# SUBMISSIONS REPORT

**Main Report**

June 2013

**Kurnell Port and Berthing Facility**

**PROJECT SITE AND CONTEXT  
(REVISED FIGURE 1-1 FROM THE EIS)**

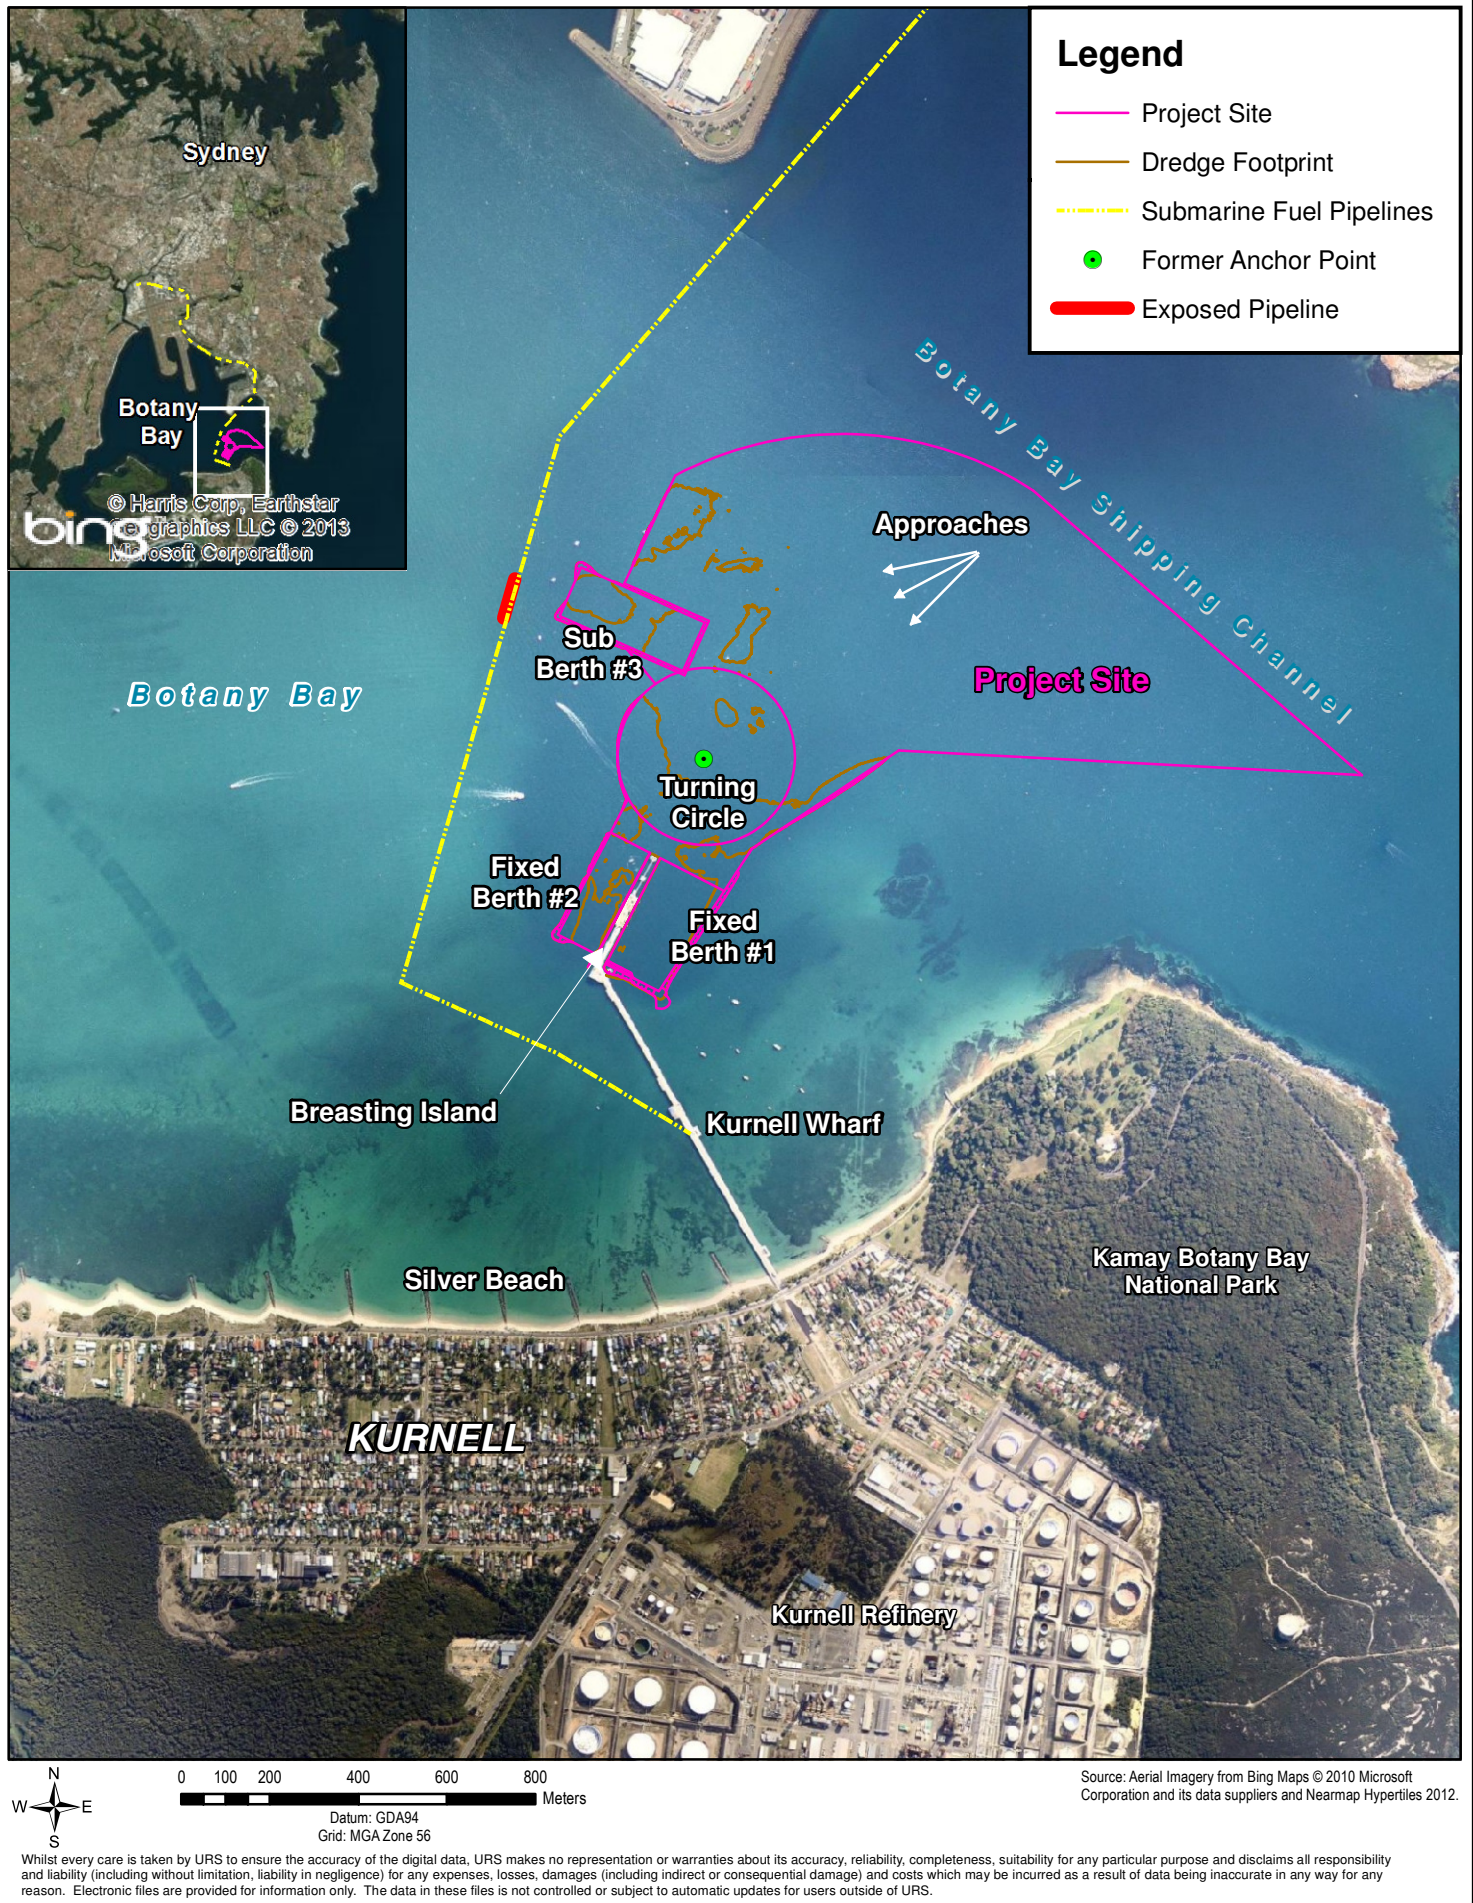
Figure 4-6 shows the location of the Former Anchor Hole which would be filled with clean material during the dredging operations. Figure 1-1 shows a Former Anchor Point which is in a different location to Figure 4-6. It is unclear from the EIS whether these two points are the same or whether they are two separate reference points. Caltex should clarify this comment as Figure 1-1 has been included in a Caltex Community Information leaflet in February 2013.

**Response:** The location of the 'former anchor point' as shown on Figure 4-6 is correct. The anchor point on Figure 1-1 is mislabelled and actually represents the location of one of the current sub-berth anchor points. A corrected figure (see **Figure 3-1**) is provided below.

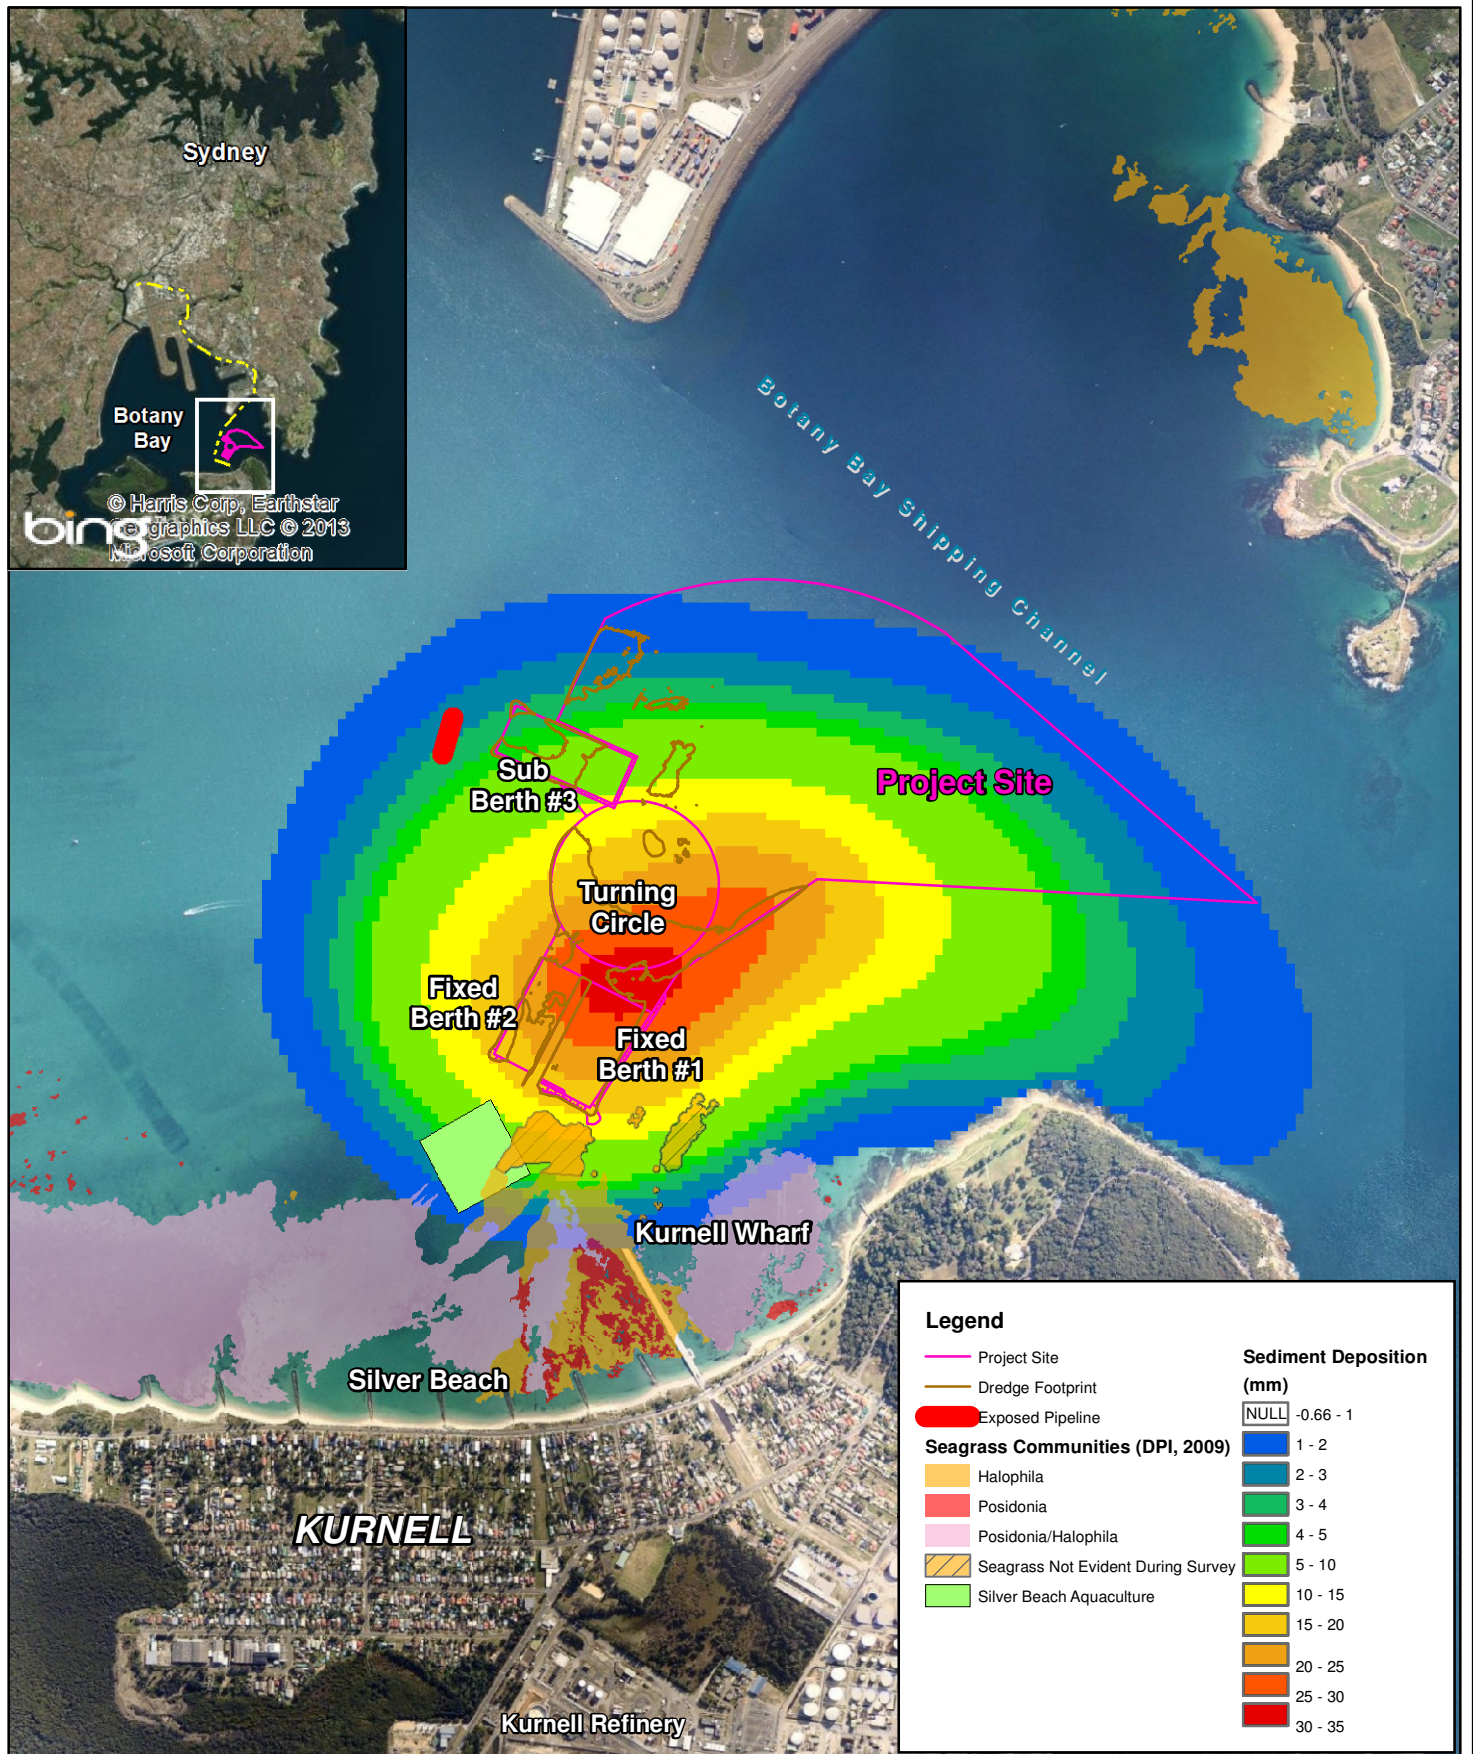
Section 10.6.3 (Page 10-16) [of the EIS] states that "It is predicted that only above 15 mm of deposition (largely within the dredge footprint, see Figure 10-3) would there be an exceedance of the ISQG-low threshold limit".

The sediment deposition scale provided in Figure 10-3 does not clearly demonstrate that above 15 mm of deposition is largely within the dredge footprint. Figure 10-3 should be revised to reflect the value provided in Table 10-3 so it is clear that the predicted deposition would not result in a sediment-bound TBT concentration of less than  $5 \mu\text{gSn.kg}^{-1}$  outside the project site; particularly near the Kurnell Wharf, aquaculture site and Kamay Botany Bay National Park.

**Response:** Figure 10-3 of the EIS has been included as **Figure 3-3** in this Report. This Figure shows the previously reported deposition with a further refinement of the deposition scale (and therefore depths) for clarification.

The deposition plot provided in the EIS (as revised under **Figure 3-3**) is based on the above conservative criteria and it provides an upper-limit benchmark for potential deposition levels. Consequently, the results provide the maximum possible impact on the seagrass beds, aquaculture site and Kamay Botany Bay National Park. However, the likelihood of this outcome occurring at the maximum, worst case, level in all these locations would be exceptionally low.
